PROJECT:
MENLO COMMONS
2140 Santa Cruz Ave, Menlo Park, CA 94025

CONTRACTOR
**PRELIMINARY PLANS
NOT FOR CONSTRUCTION**
SHEET TITLE:
PROPOSED FLOOR PLAN

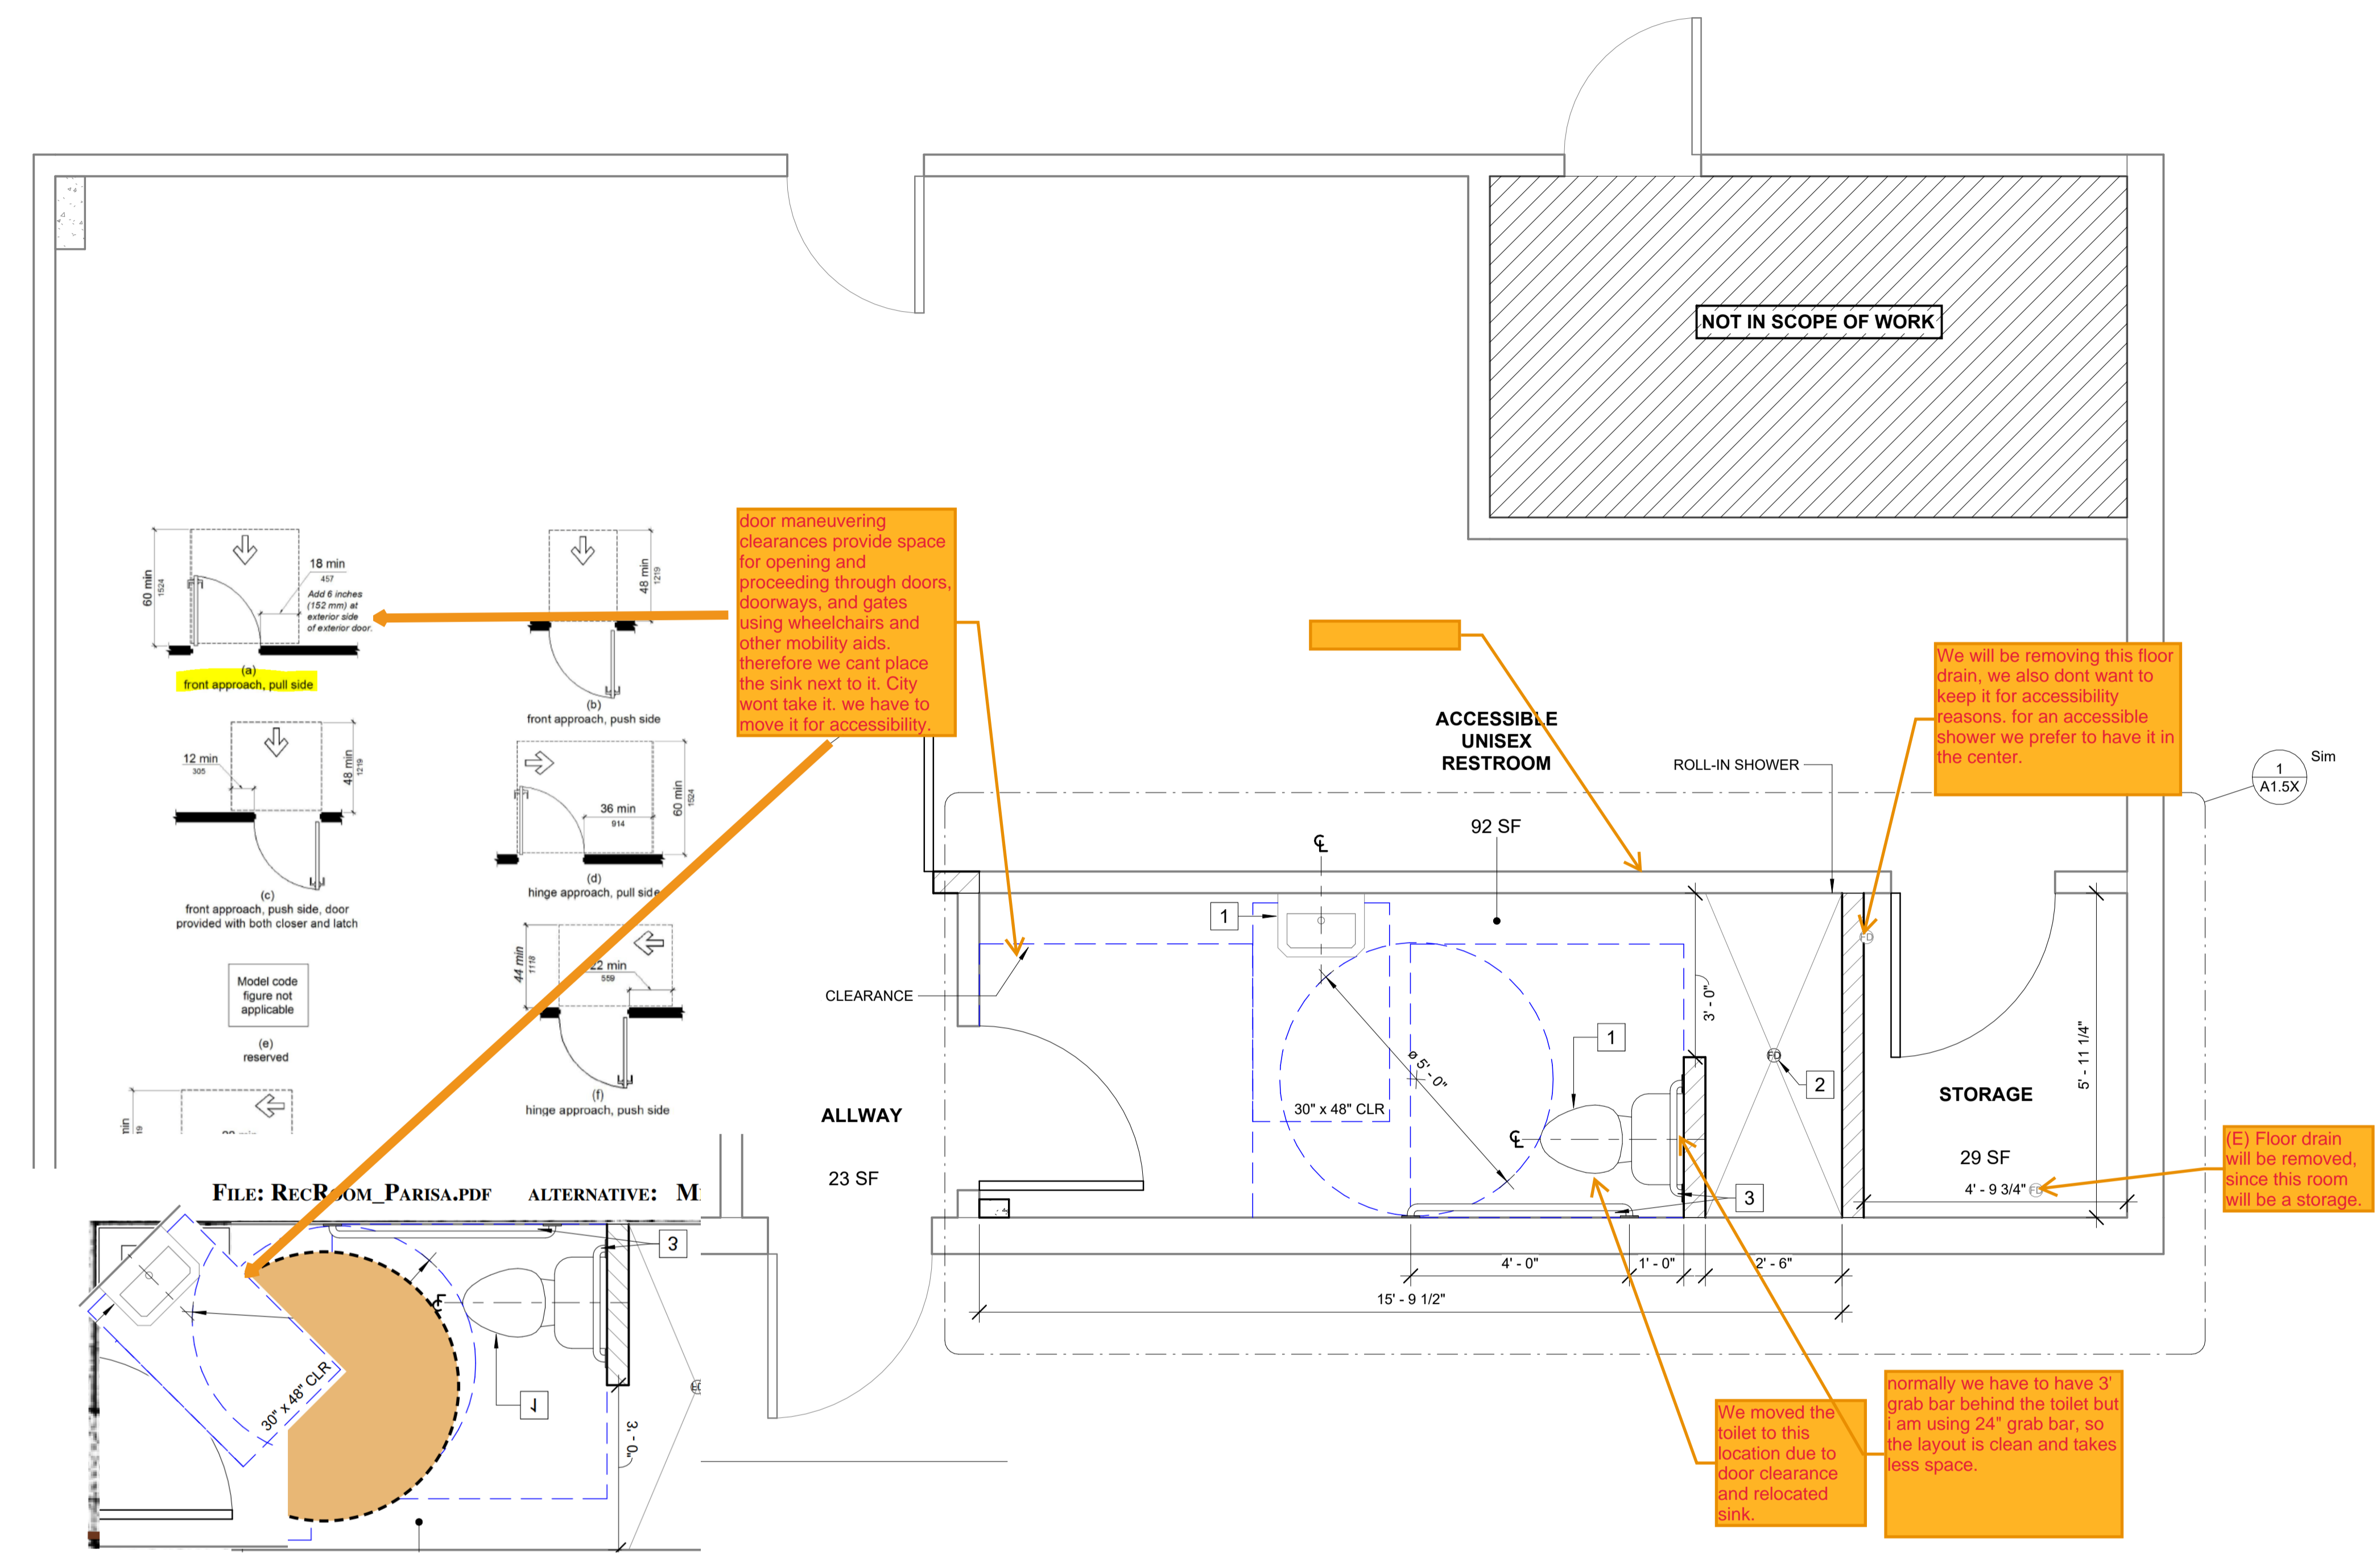
door maneuvering clearances provide space for opening and proceeding through doors, doorways, and gates using wheelchairs and other mobility aids. therefore we cant place the sink next to it. City wont take it. we have to move it for accessibility.

We will be removing this floor drain, we also dont want to keep it for accessibility reasons, for an accessible shower we prefer to have it in the center.

(E) Floor drain will be removed, since this room will be a storage.

We moved the toilet to this location due to door clearance and relocated sink. normally we have to have 3' grab bar behind the toilet but i am using 24\" grab bar, so the layout is clean and takes less space.

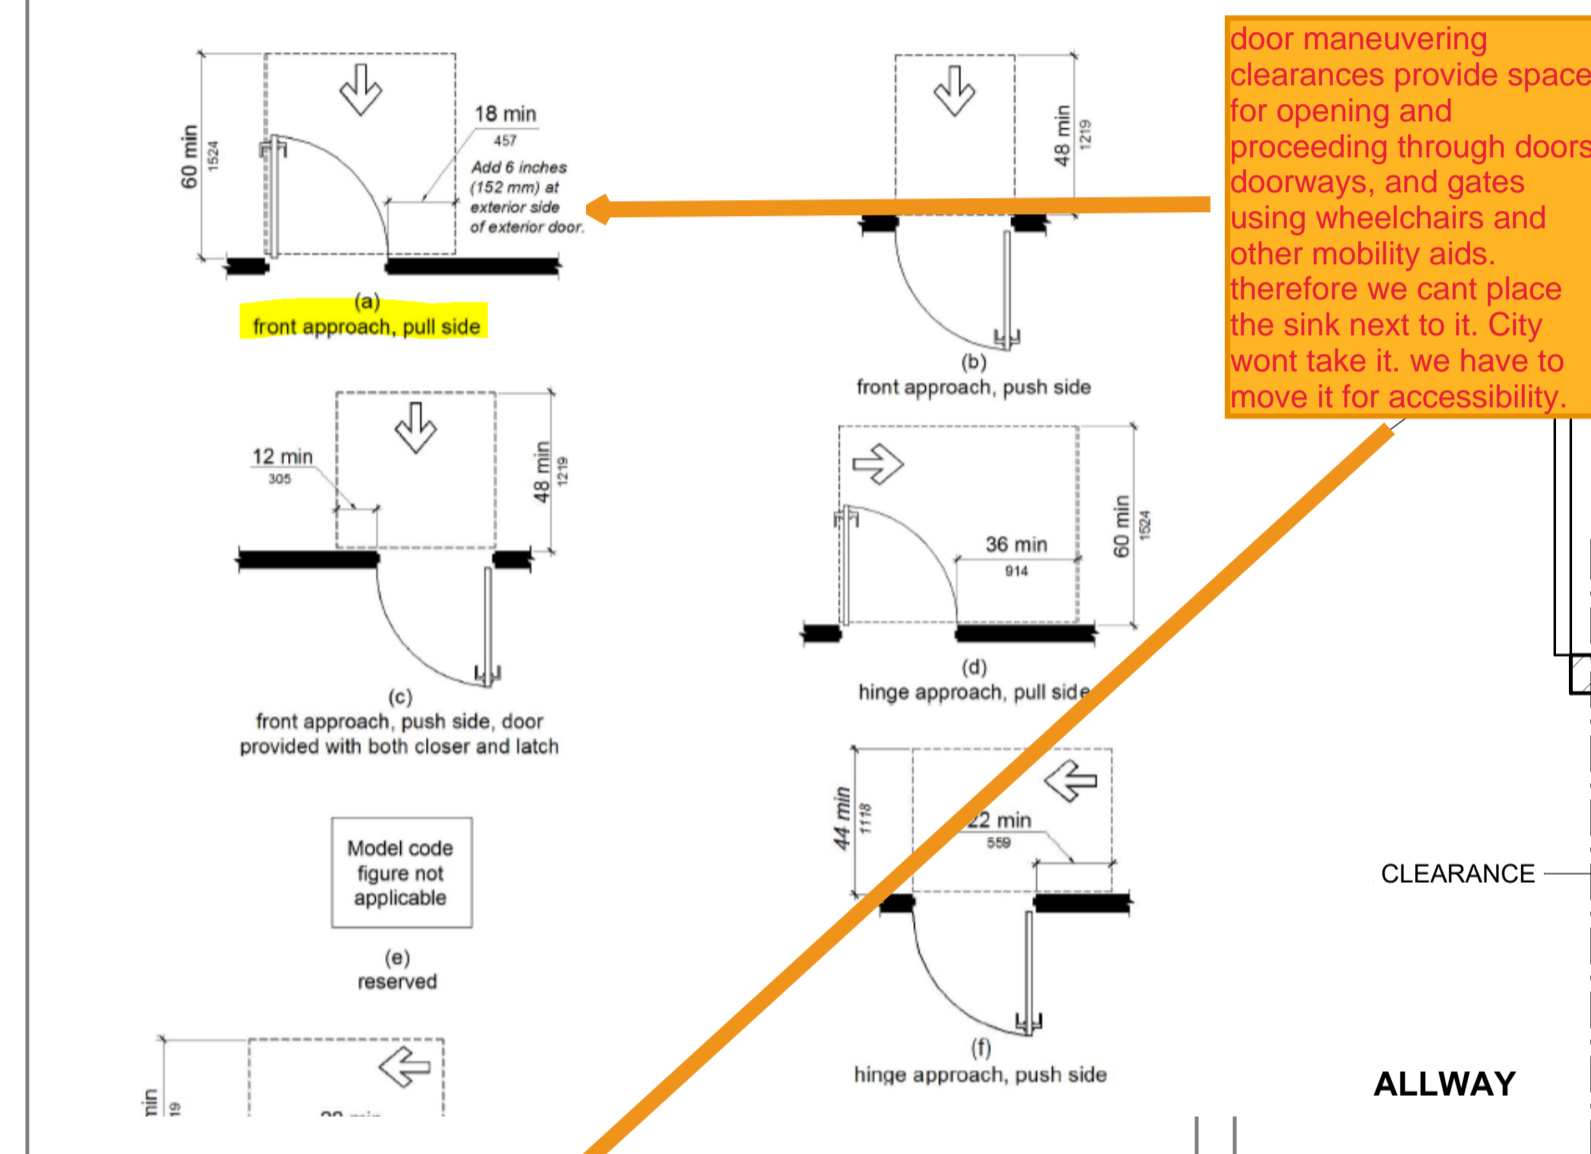
we can also do this option, with this option we are removing the existing wall and building a new one. restroom can get smaller if we build a new wall. this is just a quick layout i put together for you to see.
